The Legacy Way Project

Application for Project Change

Construction Workforce Parking Park and Ride - Toowong

May 2011

Legacy Way
Figure 2.7 - Proposed Construction
Workforce Parking Area within Existing
Park and Ride Car Park

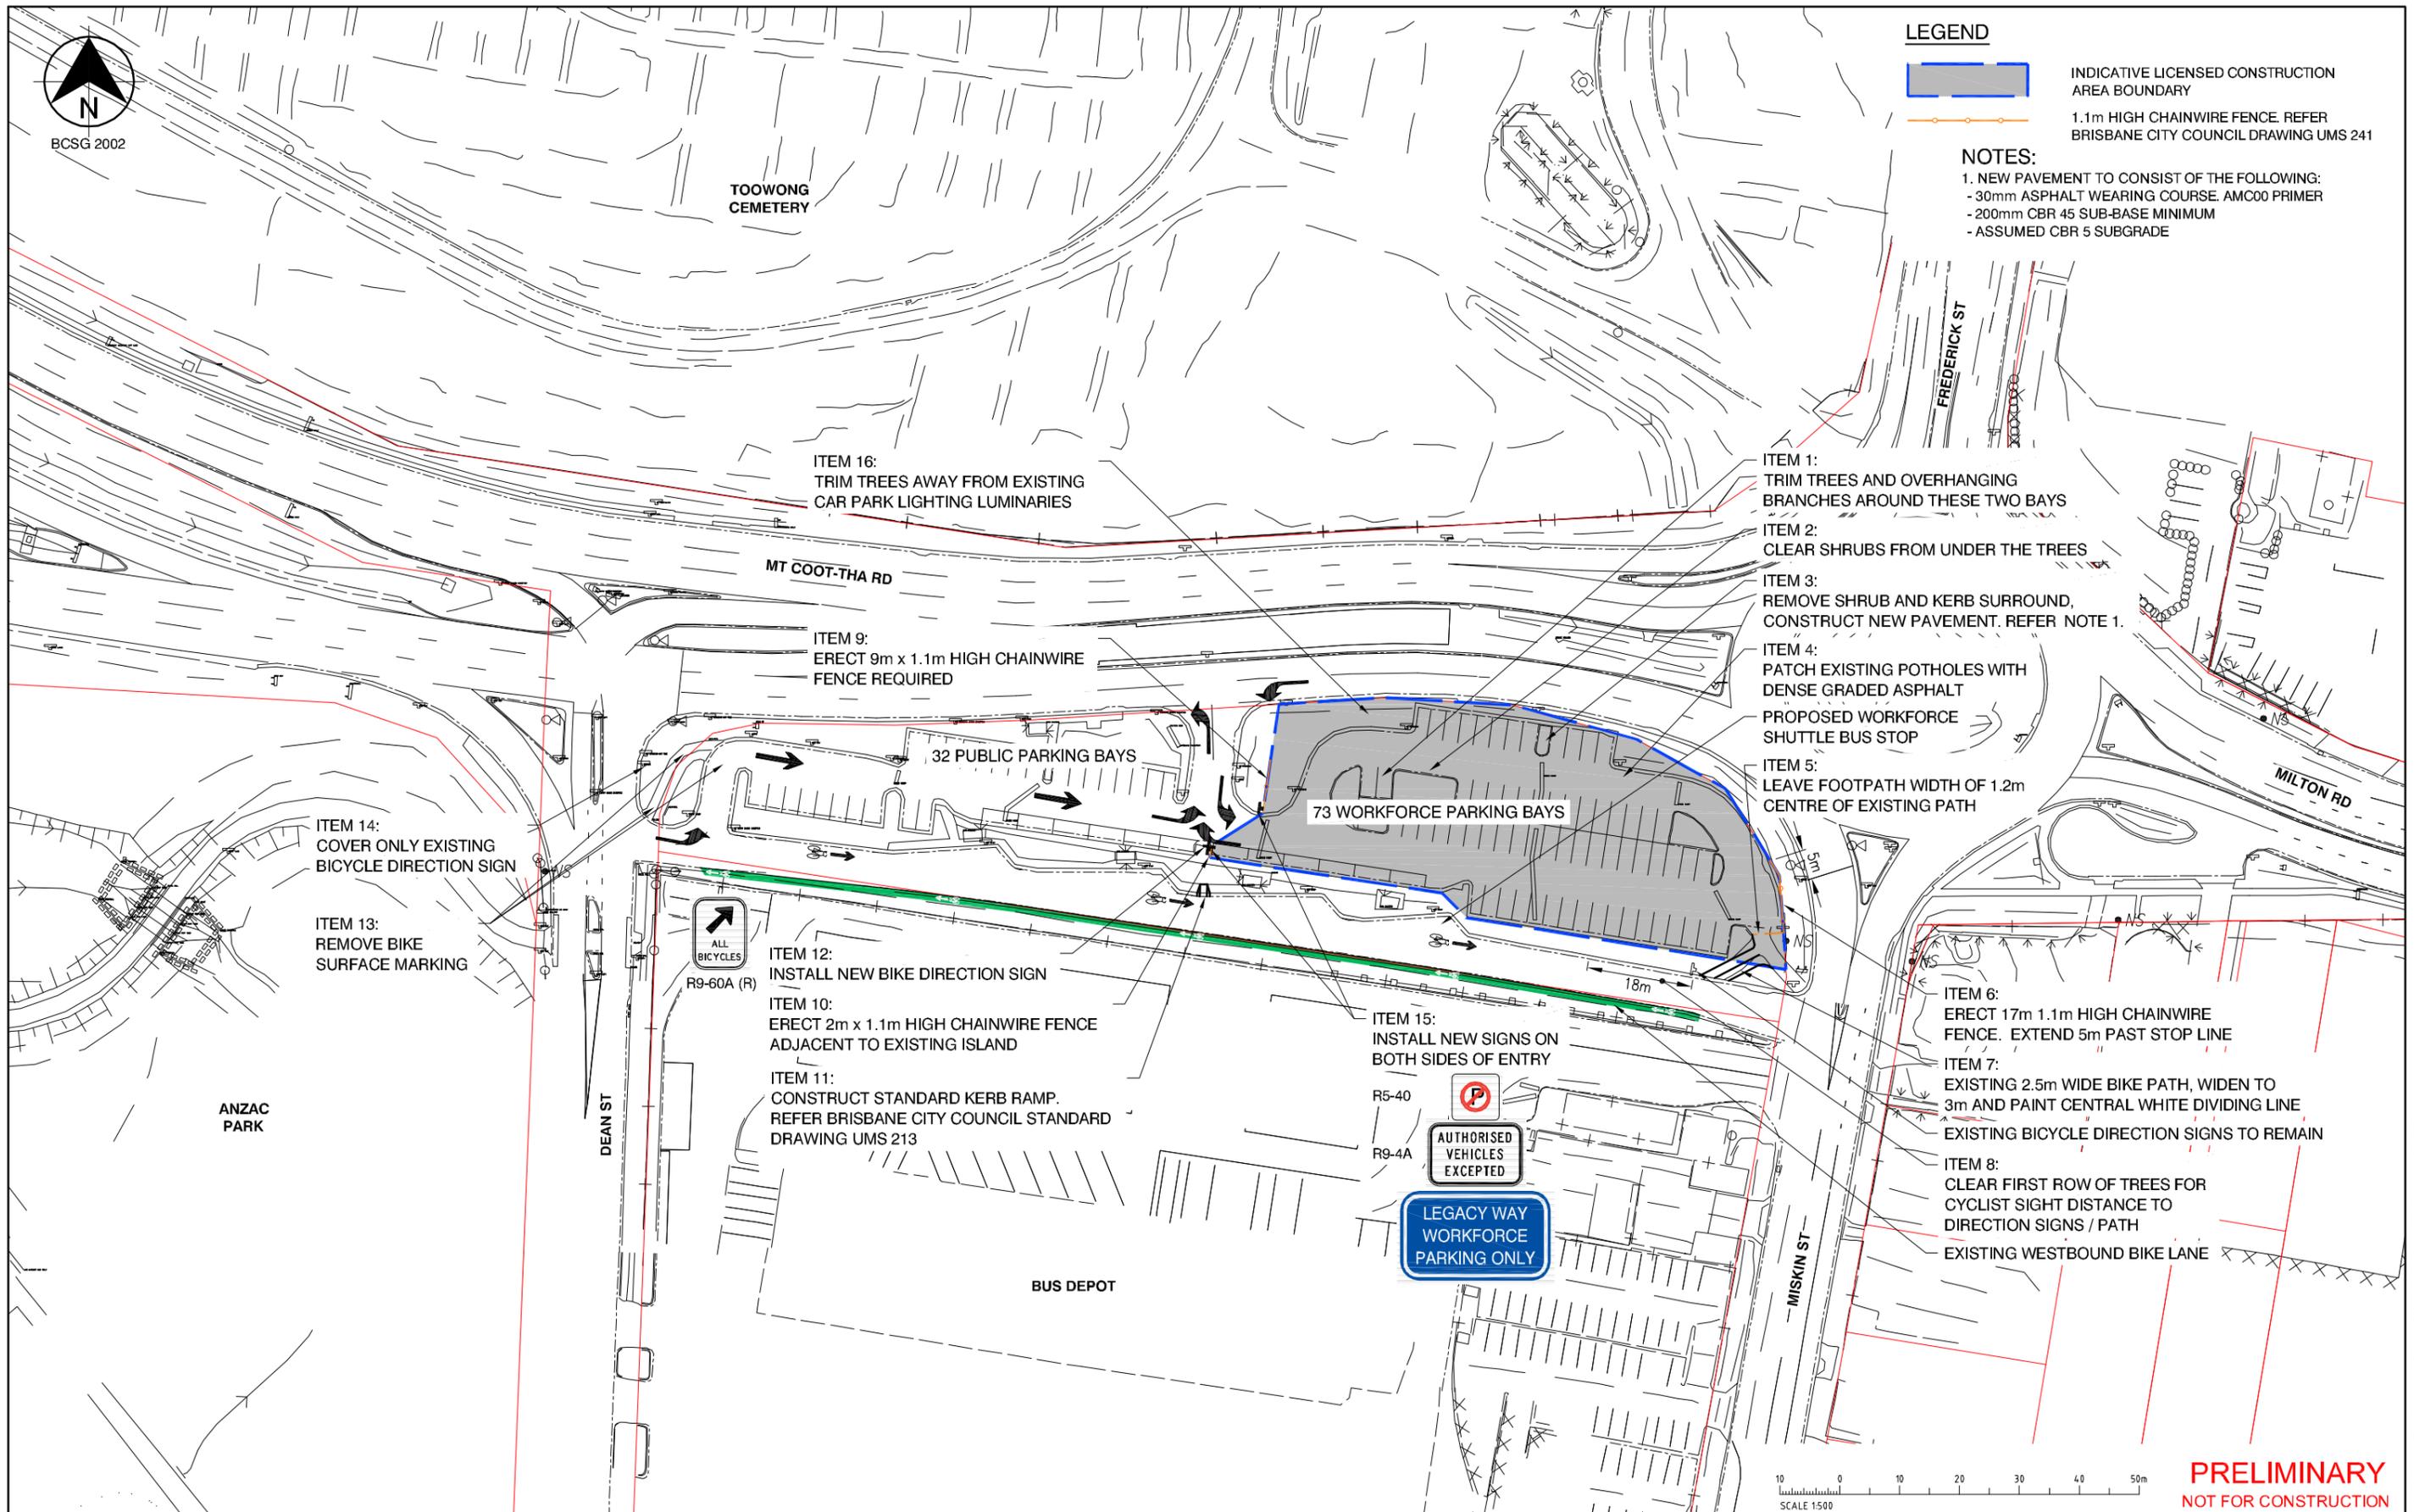
The proposed plan (as shown on **Figure 2-7**) is to retain 32 of the existing 104 spaces at the western end of the car park for continuing public use with 72 retained at the eastern end for the workforce. A further parking space will be created in this eastern end through the removal of a small landscaped area and associated plant required to improve driver sight lines exiting the car park onto Mt Coot-tha Rd. This would then provide approximately 73 car parks in total for the construction workforce. Signs will be erected on both sides of the entrance to the segregated car park indicating *Legacy Way Workforce Parking Only*, with no parking except by authorised vehicles.

It is proposed to install a short extent of 1.2m high chain wire fence either side of the entrance to the parking area to aid in delineating the eastern designated construction workforce parking area. The installation of "banana bars" or a similar barrier is proposed on the existing bicycle/pedestrian path at the eastern end to prevent vehicles from using the bicycle path to exit the car park onto Miskin Street. Vehicle tyre marks are visible on the path which indicates that the path is being used at times by motor vehicles.

The issue associated with displacing existing users of the car park would be addressed through the preservation of 32 parking places in the western section of the existing car park in order to minimise the potential impacts to the surrounding area and public transport patronage. The western portion of the car park (west of the entrance from Mt Coot-tha Road and adjoining Dean Street) will be maintained as a commuter car park, with the eastern portion of the car park sectioned off for workforce parking as shown on **Figure 2-7**.

The potential for impacts on local traffic, including increased traffic on local streets and impacts on surrounding active transport routes have been addressed through site design restricting access only to and from Mt Coot-tha Road and left in off Dean Street, from Mt Coot-tha Road for the 32 park and ride spaces (as shown by the directional arrows on **Figure 2-7**). This would limit potential local traffic routes for construction workers to Miskin Street as required to access Mt Coot-tha Road, with no right turn access from Dean Street, heading north, into the parking area. Signage and associated fencing where necessary will help direct active pedestrian and cycle movements either through or around the site and will also restrict current illegal access from the parking area to exit using the existing bikeway adjacent to Miskin Street.

- ITEM 1: TRIM TREES AND OVERHANGING BRANCHES AROUND THESE TWO BAYS
- ITEM 2: CLEAR SHRUBS FROM UNDER THE TREES
- ITEM 3: REMOVE SHRUB AND KERB SURROUND, CONSTRUCT NEW PAVEMENT. REFER NOTE 1.

- ITEM 9: ERECT 9m x 1.1m HIGH CHAINWIRE FENCE REQUIRED
- ITEM 10: ERECT 2m x 1.1m HIGH CHAINWIRE FENCE ADJACENT TO EXISTING ISLAND
- ITEM 11: CONSTRUCT STANDARD KERB RAMP. REFER BRISBANE CITY COUNCIL STANDARD DRAWING UMS 213

- ITEM 12: INSTALL NEW BIKE DIRECTION SIGN
- ITEM 13: REMOVE BIKE SURFACE MARKING
- ITEM 14: COVER ONLY EXISTING BICYCLE DIRECTION SIGN
- ITEM 15: INSTALL NEW SIGNS ON BOTH SIDES OF ENTRY
